**ADDENDUM NUMBER TWO**

Date: January 22, 2023

Re: **EB-5894 – Black Creek Greenway**  
**BL-0024 – NW Cary Parkway Sidewalk at Black Creek**

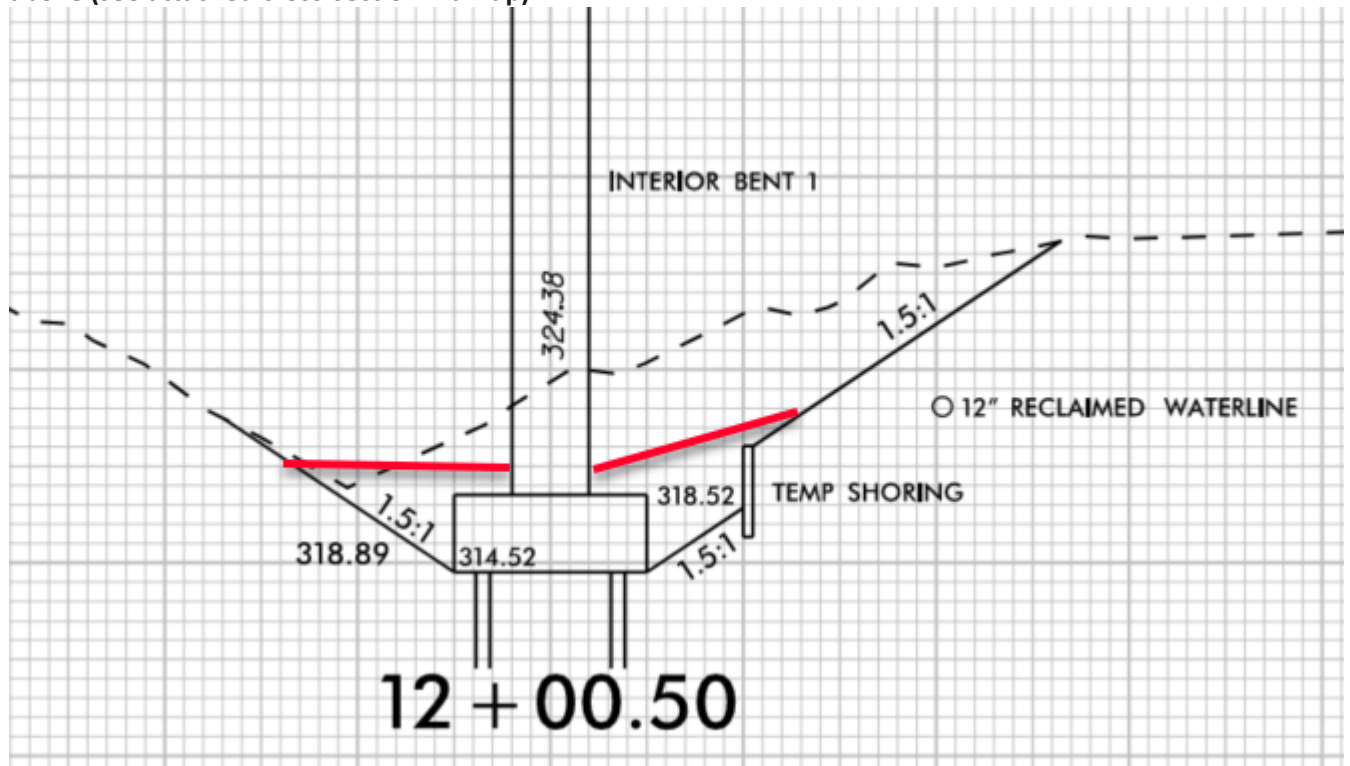
- Q4.** Are the footers for BL-0024 Bridge columns supposed to be left exposed or covered up with dirt? The cross sections show the footers being left exposed.
- Revised Response: BL-0024 – The cross sections show the construction situation where we need to excavate down to the bottom of footing and utilize temporary shoring. Final conditions would include soil above the footing and grading the area to drain. The footing elevations were set to include at least 18 inches of soil**

above (see attached cross-section markup).
